Re: Petition of KCE CT 8, LLC for a Declaratory Ruling that no Certificate of Environmental Compatibility and Public Need is Required for the Proposed Construction, Operation and Maintenance of a 4.9-megawatt (“MW”) Battery Energy Storage System, to be Located at 44 Skinner Street, East Hampton, Connecticut

**STATE OF CONNECTICUT
CONNECTICUT SITING COUNCIL**

Petition No. 1581

Petitioner KCE CT 8, LLC (“KCE”) hereby submits the following responses to the Interrogatories that were directed to KCE by the Connecticut Siting Council (“CSC” or “Council”) on July 21, 2023.

Barton & Loguidice logo and contact information. Project details for ALTA/NSPS LAND TITLE SURVEY for KEY CAPTURE ENERGY, LLC at KCE CT8 EAST HAMPTON. Includes project number 4428-001-004, date 11/1/22, and sheet number 1 of 1.

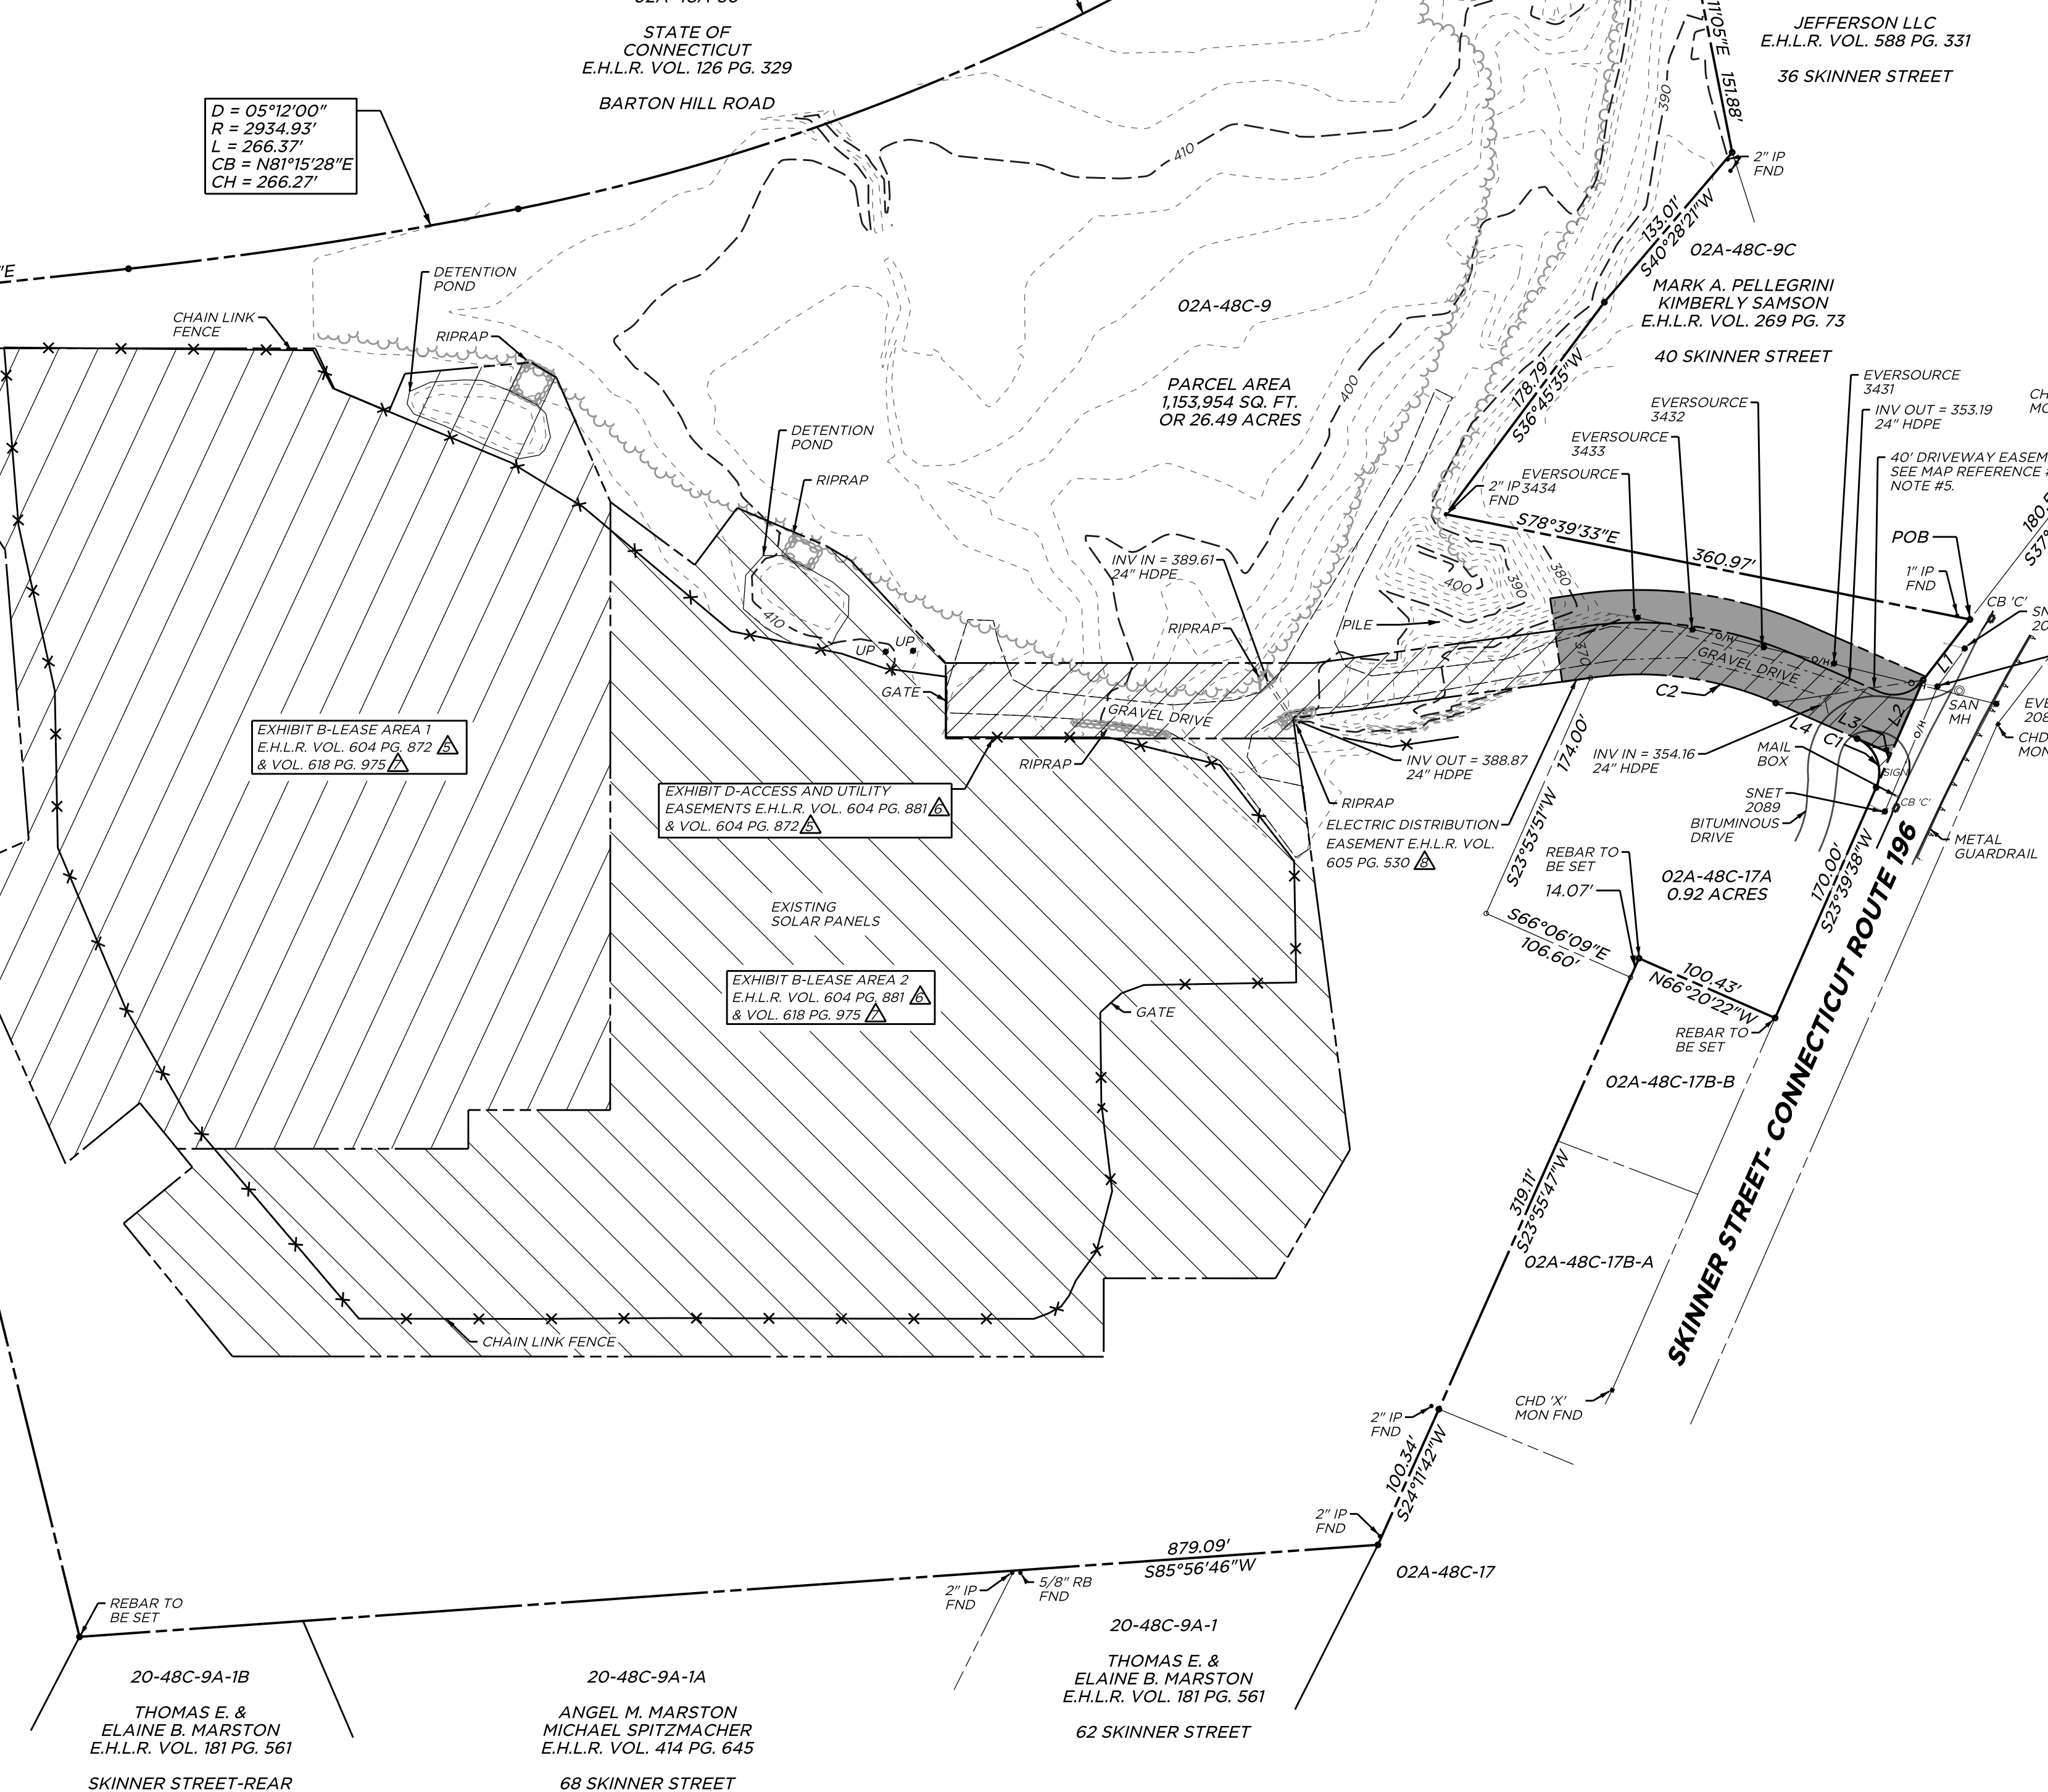
- 10. Referencing Figure 3, ALTA/NSPS Land Title Survey and Sheet C-2.0, would KCE share the existing access drive for the solar facility site off Route 196/Skinner Street? What is the length and width of the existing access drive to the point where it would turn on the proposed access drive for the battery energy storage facility?**

11. Referencing Figure 3, ALTA/NSPS Land Title Survey and Sheet C-20, what is the length of the proposed 24-foot wide access drive for the battery energy storage facility? Is the turning radius and vehicle passage area from the existing access drive to the proposed access drive sufficient for construction vehicles?

Yes, although the project is unrelated to the solar facility, the proposed project would share the existing access drive with the solar facility that coexists on the host parcel. Upon completion of project construction, it is anticipated that vehicular traffic for the solar facility and the BESS facility would each be extremely minimal for Operations & Maintenance. The shared access drive is approximately 400 feet in length and the width varies between approximately 13 feet and 24 feet.

The proposed 24 foot wide access drive is approximately 36 feet long between the point it tapers to match the existing road width and the sound wall gate. Truck-turning software in AutoCAD was used to determine that a WB-40 truck is anticipated to be able to navigate the existing/proposed road network.

Photo Log Map

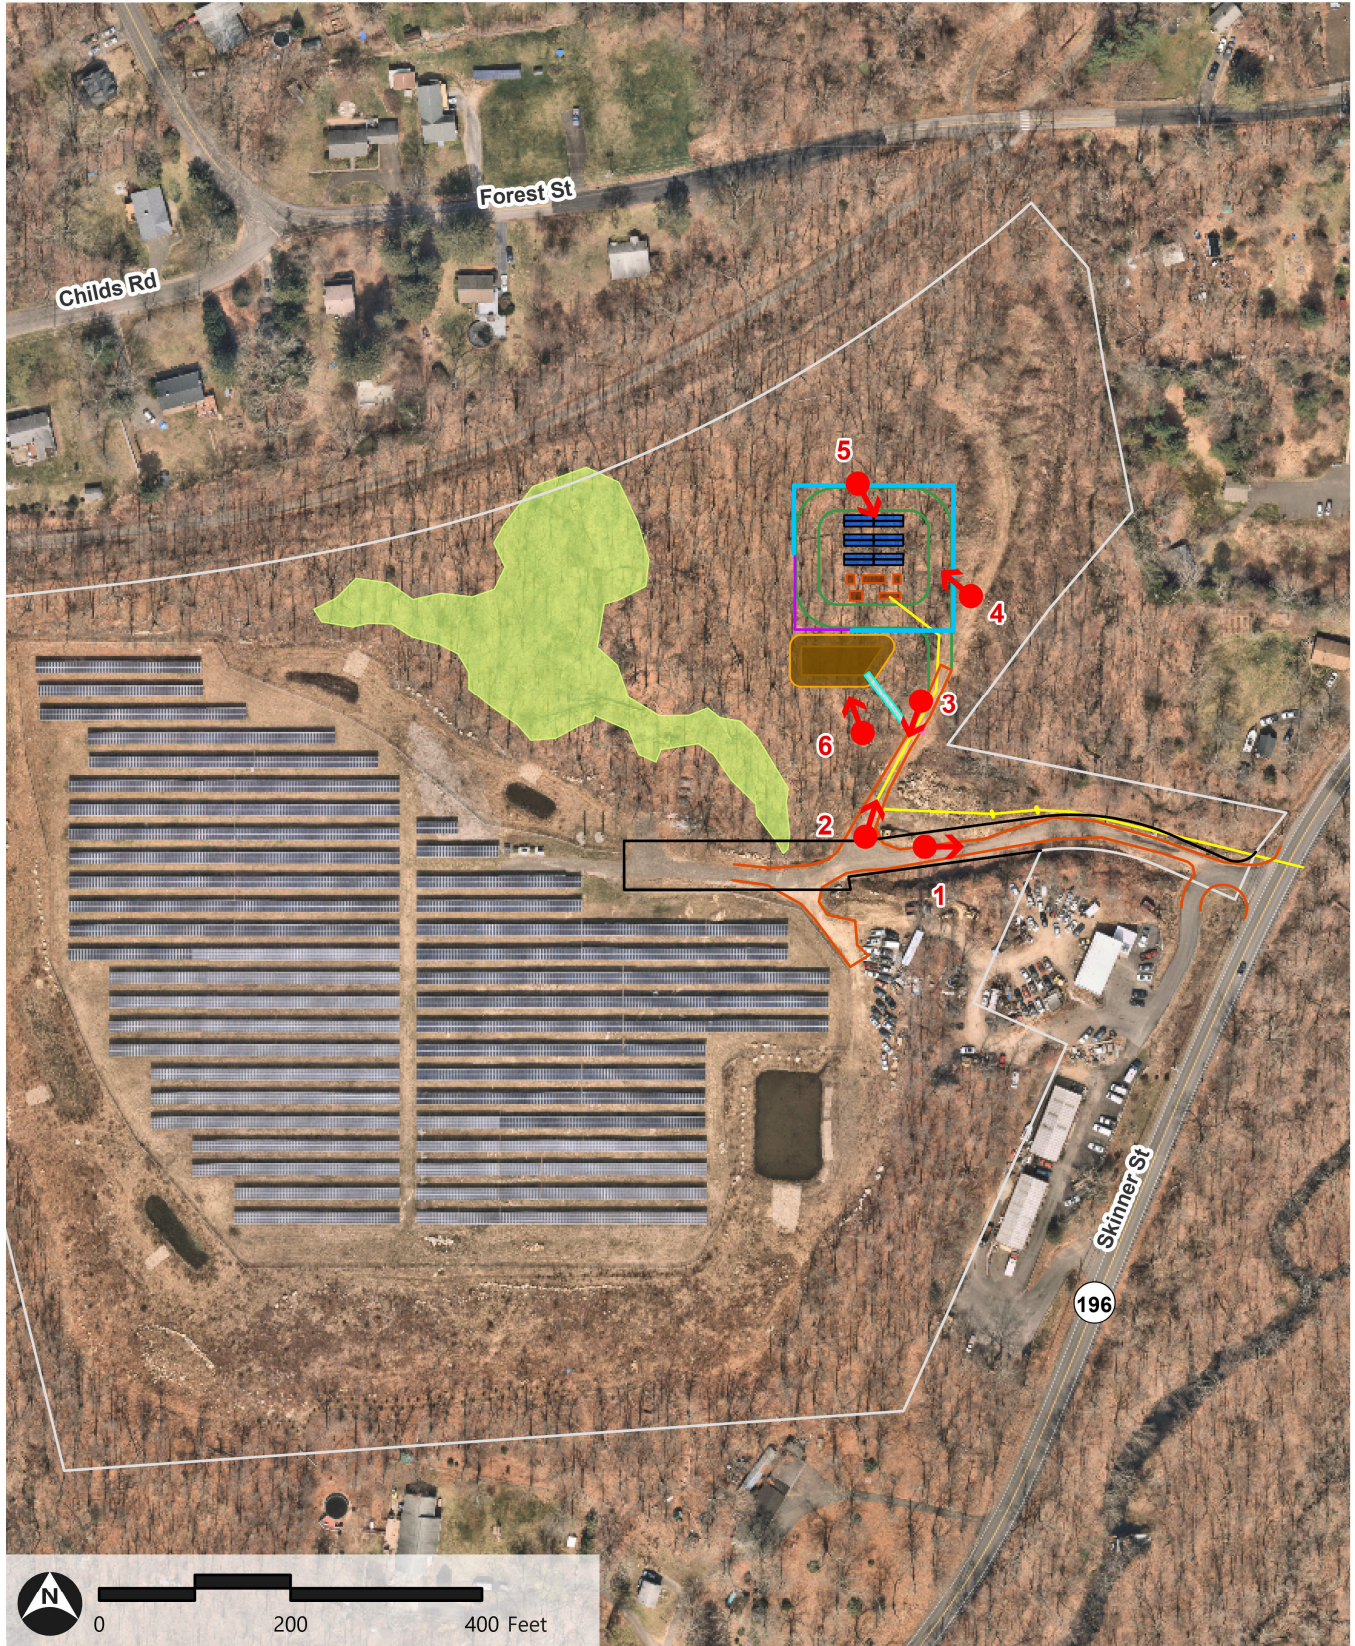
54. **Please submit photographic site documentation with notations linked to the site plans or a detailed aerial image that identify locations of site-specific and representative site features. The submission should include photographs of the site from public road(s) or publicly accessible area(s) as well as Site-specific locations depicting site features including, but not necessarily limited to, the following locations as applicable:**
